SCHEDULE A: Applications with Recommendation

13/0047

Buck Bottom Farm, Burgh by Sands, CA5 6AN

Proposal: Erection Of 3No. Dwellings, Conversion Of Barn To 1No. Dwelling And

Plot 1

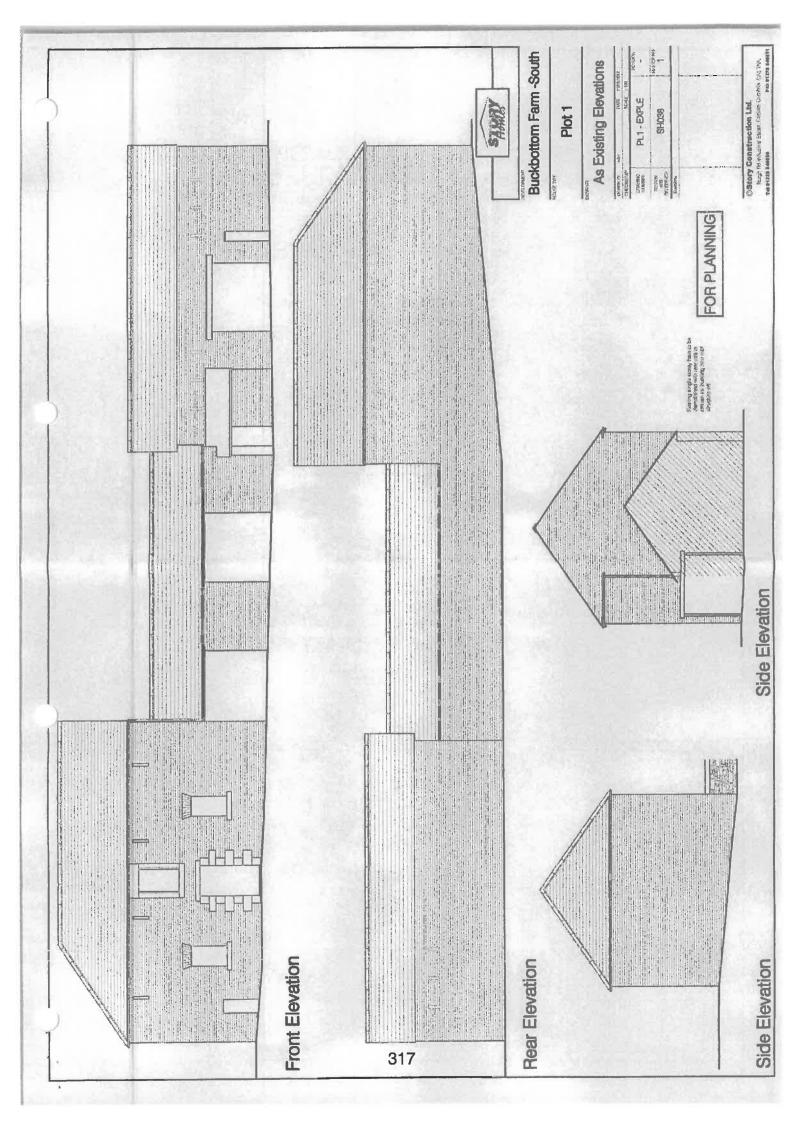
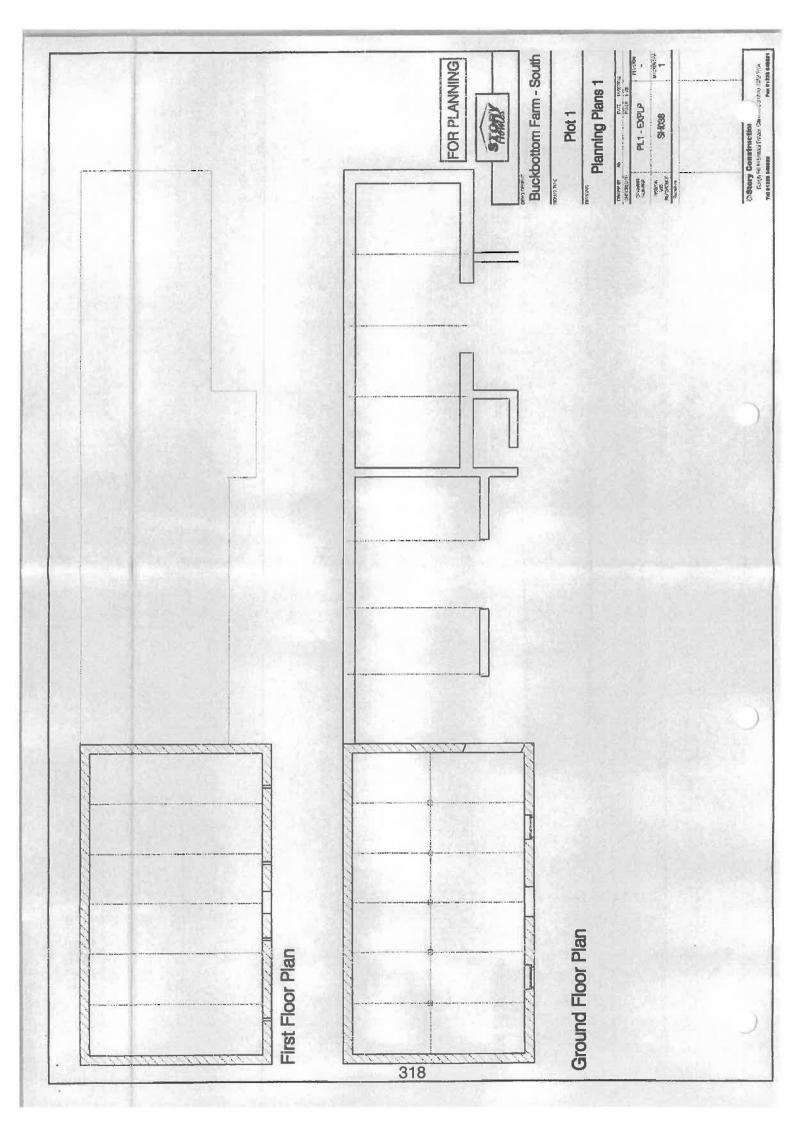
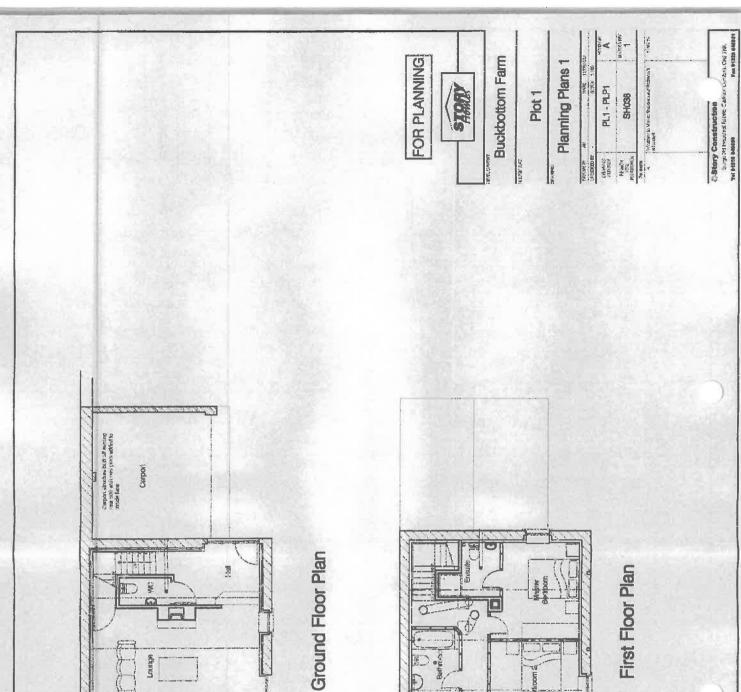
Conservation Area Advisory Committee: - some concern was raised over the three new windows in the road elevation of the converted barn Plot 1. Can this quantity be reduced, perhaps by additional rooflight to bedroom 3?; excessive windows to front elevation; concern over 'domestication' of barn through proposed fenestration - can hayloft window be modified to be a plain opening rather than a domestic style sash opening?; strongly suggest retention of existing ground floor door opening to barn rather than widening; incorrect elevation compared to floorplans on barn conversion – upper floor

windows are omitted on plan; lack of clarity over boundary treatments e.g. rendered wall legend on proposed site plan is ascribed to stone wall to Plot 1; quoins to plots 3 and 4 are very undersized - suggest increasing dimensions by at least 50% to reflect traditional building proportions. Recommendation – suggest that the proposal should be recommended for approval subject to modification of the above.

- 6.4 The Conservation Area Advisory Committee has raised concerns about the insertion of three new windows in the roadside elevation of the converted barn. These windows have, however, been agreed with the Council's Heritage Officer following a site meeting and have resulted in the removal of two new windows at first floor level in the front elevation of the building. It has also raised concerns about the hayloft window in the converted barn being too domestic in appearance and the quoins proposed in the two new dwellings to the rear of site being undersized. Conditions have been added to the consent of ensure that details of the hayloft window in the converted barn and the details of the quoins on Plots 3 & 4 are agreed with officers prior to the commencement of development.

21. Prior to the commencement of development, details of the proposed first floor window in the front elevation of Plot 1 shall be submitted to and approved in writing by the Local Planning Authority. The window shall then be installed in accordance with these details.

Plot 2

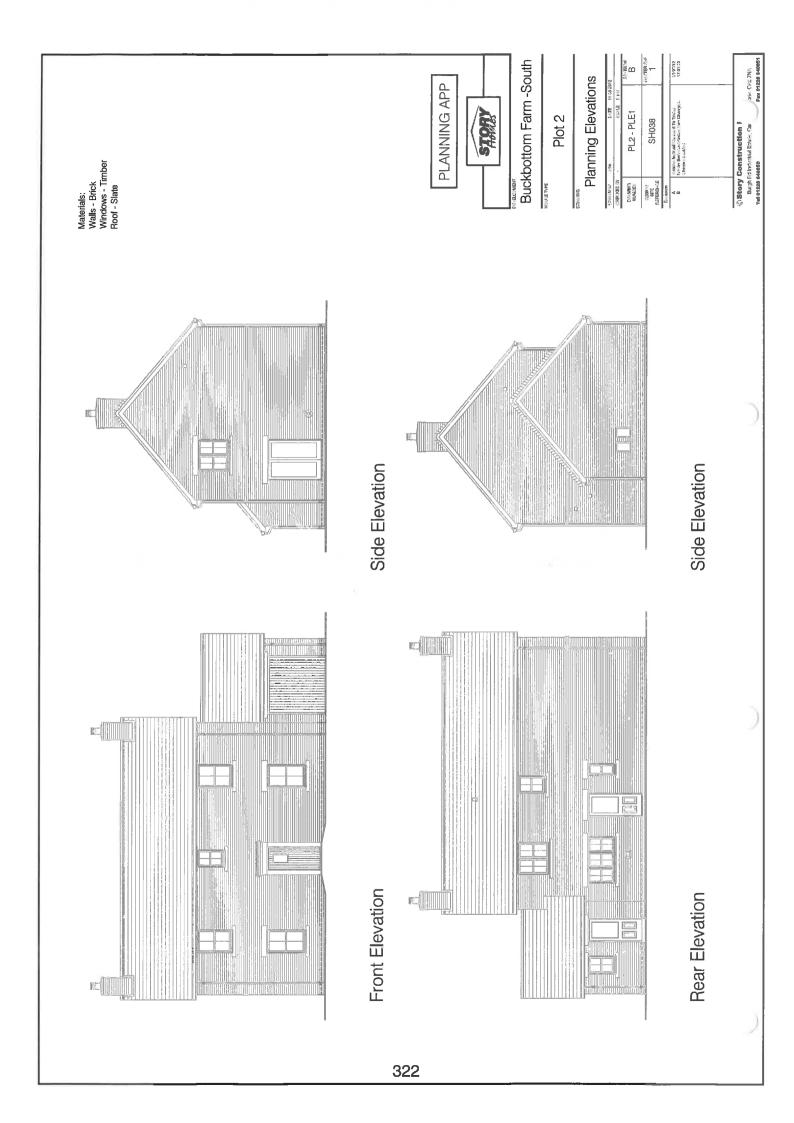
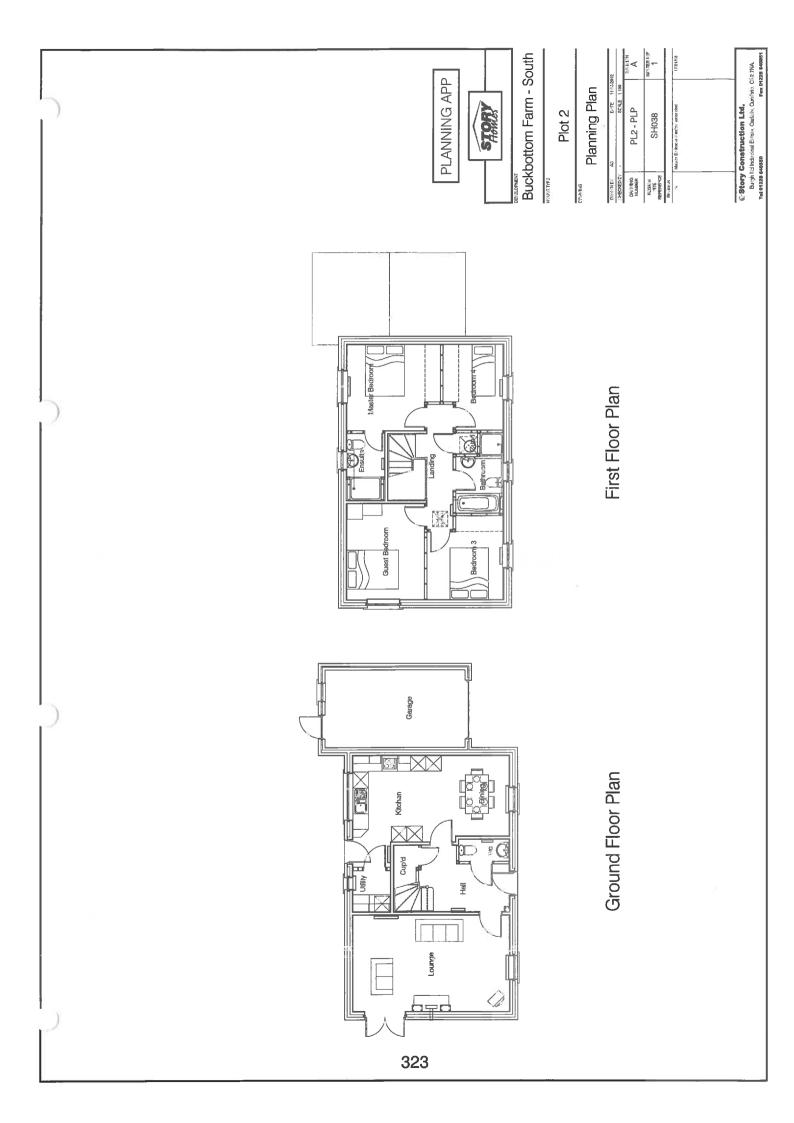
- this development includes 3 properties sharing a boundary with Cross Farm 2
 of these are new large two-storey houses within a few metres of the boundary.
 The 'guest' bedroom of plot 2 has 1 window which may overlook the private
 courtyard of Cross Farm and the kitchen window of Cross Farm;

- the proposed 1.8m high concrete rendered wall around the front garden of plot 2, would be much better as a random cobble wall in keeping with the rest of the village;

- 6.13 The occupiers of Cross Farm have raised concerns about a bedroom window at first floor level in the side elevation of Plot 2 overlooking their property. This window would, however, be over 22m away from the rear elevation of Cross Farm and would not directly face it. Whilst there would be two windows on the rear elevation of Plot 2, which would overlook part of the garden of Cross Farm, one of these would serve an en-suite bathroom, with the other serving a bedroom. Overlooking of the garden from a single bedroom window would be acceptable, particularly given that existing trees on the boundary would help to limit overlooking. Whilst Plot 3 would have a side elevation facing the rear section of the garden of Cross Farm, this would only contain a bathroom window at first floor level.

19. Notwithstanding the provisions of the Town and Country Planning (General Permitted Development) Order 1995, (or any Order revoking and re-enacting that Order), the first floor bathroom/ en-suite windows in the rear elevation of Plot 2, the front and side elevations of Plot 3, and the side elevations of Plot 4 shall be obscure glazed and thereafter retained as such to the satisfaction of the Local Planning Authority.

Plot 3

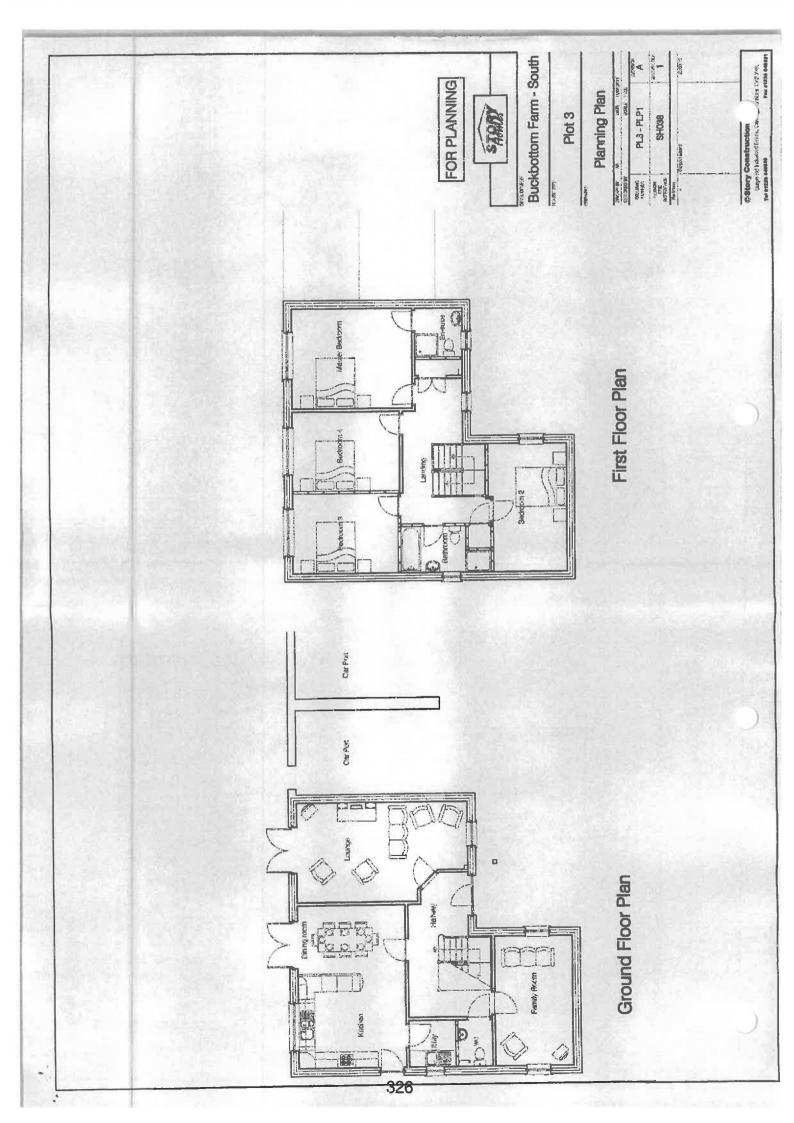
- 6.25 Following concerns from the Tree Officer, Plot 3 has been moved further to the west to ensure that it is outside the Root Protection Areas of existing trees. The Tree Officer has no objections to the amended plans, subject to conditions to deal with tree protection and landscaping.

22. Prior to the commencement of development, details of the proposed quoins on Plots 3 & 4 shall be submitted to and agreed in writing with the Local Planning Authority. The quoins shall then be constructed in accordance with these details.
